**City of University Heights, Iowa
Special Meeting of City Council**
Tuesday, August 18, 2015

August '15 – City Attorney's Report
Lot 115, University Heights 1st Addition

LOT 115, UNIVERSITY HEIGHTS FIRST ADDITION
UNIVERSITY HEIGHTS
JOHNSON COUNTY
IOWA

EXISTING SENSITIVE AREAS AND DEMOLITION PLAN

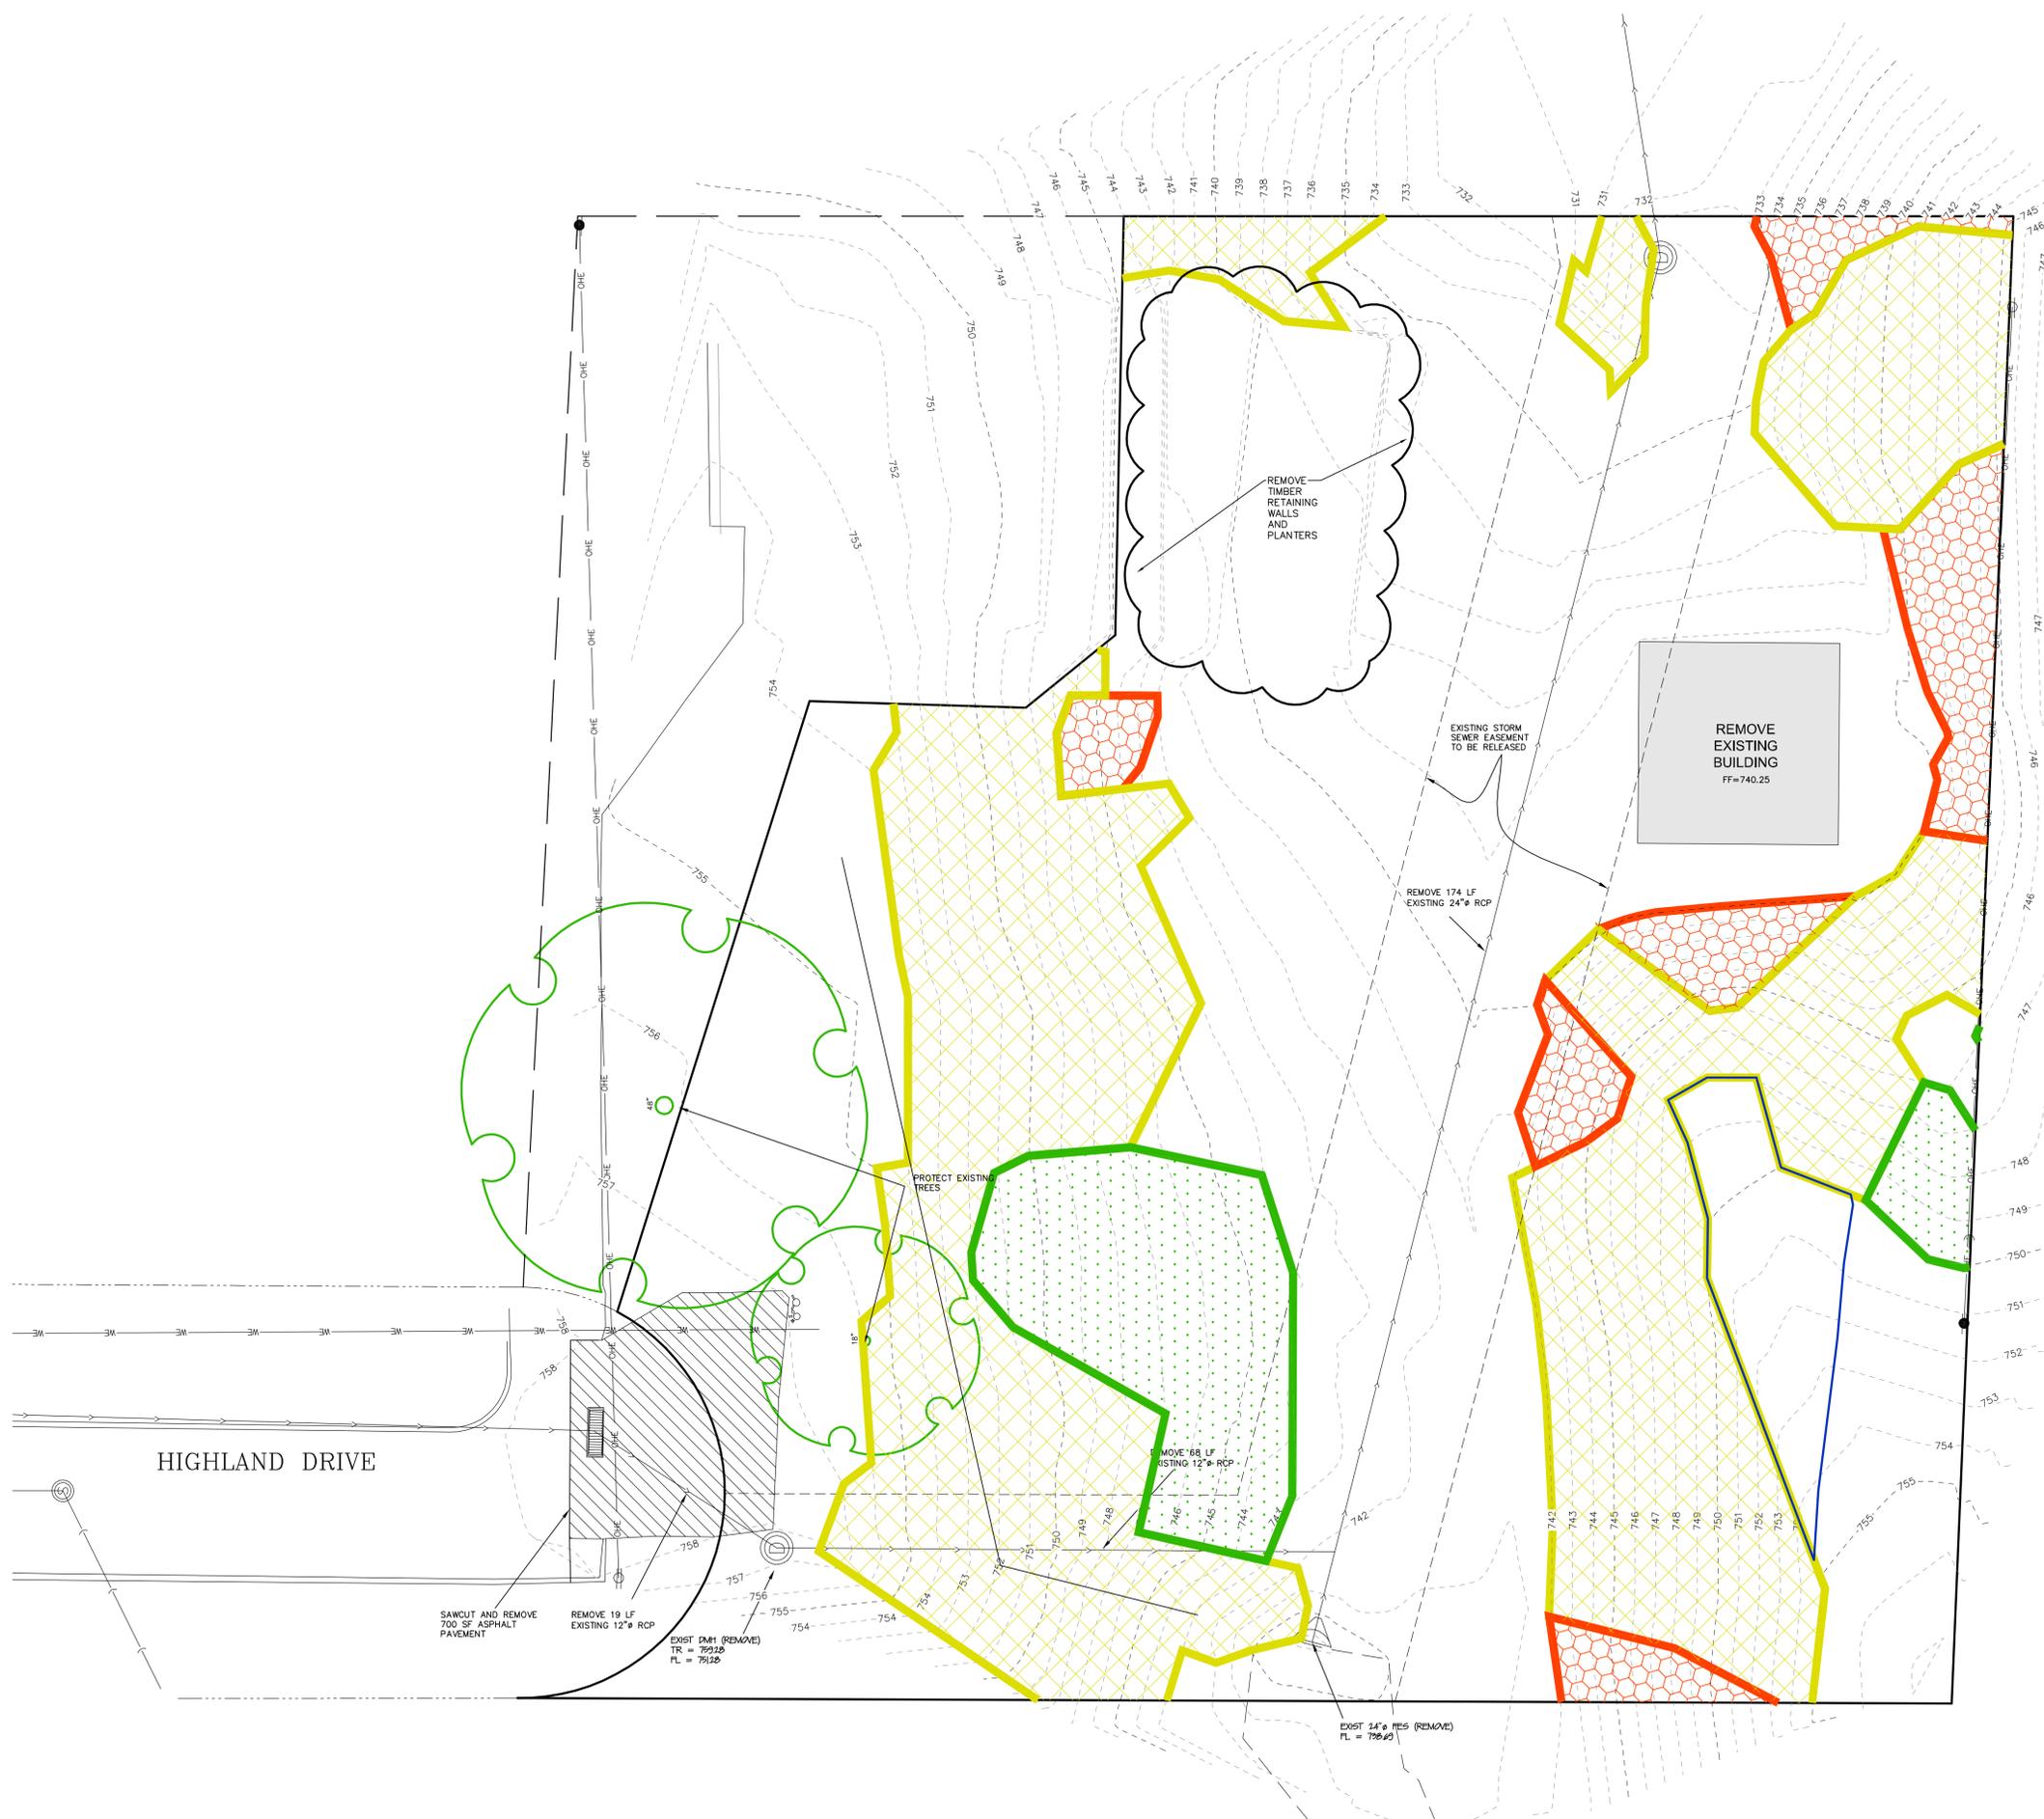
- c. The Development Plan (Sheet 2) shows existing conditions, and identifies the steep, critical and protected slope areas.
 - i. The quantities of each type of slope impacted need to be reviewed and updated. MMS may be providing revised drawings tomorrow in advance of the meeting.

PROPOSED SENSITIVE AREAS
PLAN AND GRADING &
EROSION CONTROL PLAN

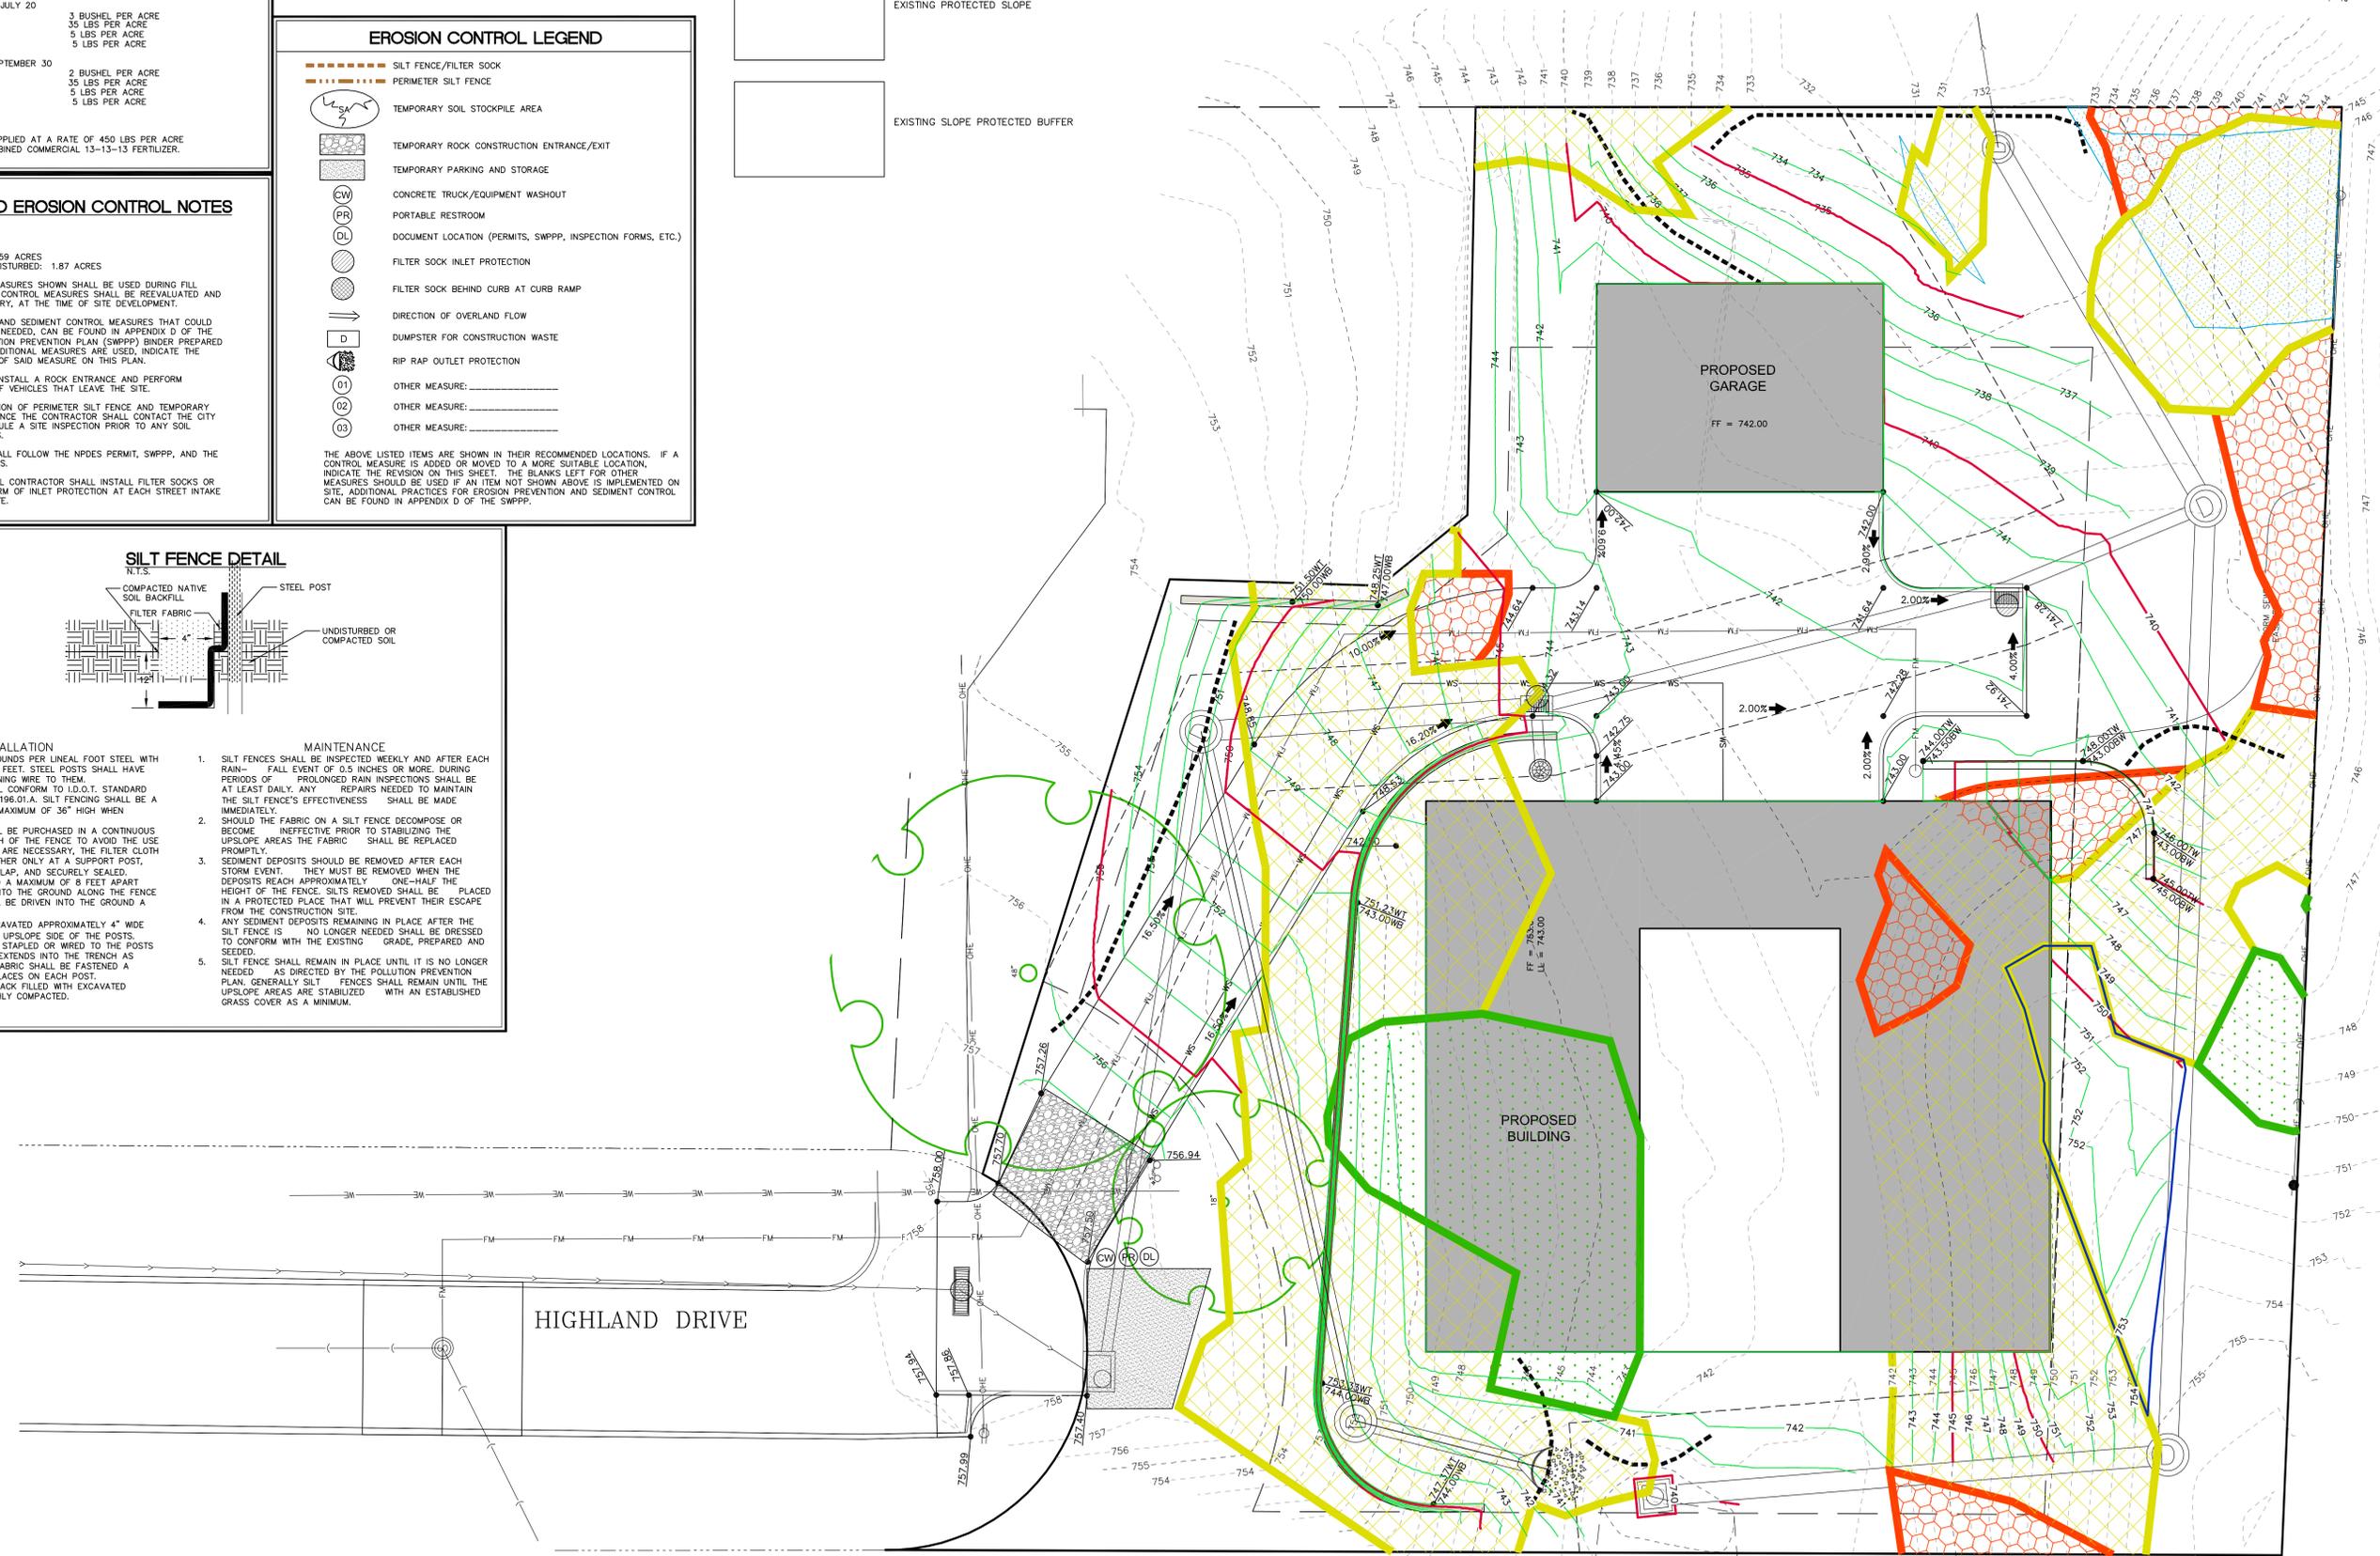
- d. The Site Plan and Grading Plan (Sheet 4) show the proposed layout and grading contours.
 - i. Based on the current site plans submitted, anticipate that all of the slope areas would be impacted by construction except the southeast corner of the lot.

- ii. The grading plan for the proposed driveway at the north end of the lot cuts the grade several feet near the large tree along the property line at 62 Highland Drive. The site plans note the tree is to be protected, but grading in this fashion would expose and require cutting through roots on the south side of the tree. This needs to be addressed before a grading plan can be approved. MMS may be providing revised drawings tomorrow in advance of the meeting.

- iii. The depth of the proposed storm manholes and storm sewer pipes around the outside of the lot create two concerns that need to be addressed:
 - 1. The pipes and structures are deep enough that the required easement widths (easement width correlates to sewer depth) extend beyond the Lot 115 property lines at several locations. If the easement widths are to remain within Lot 115, either the sewer depth or location would have to change.
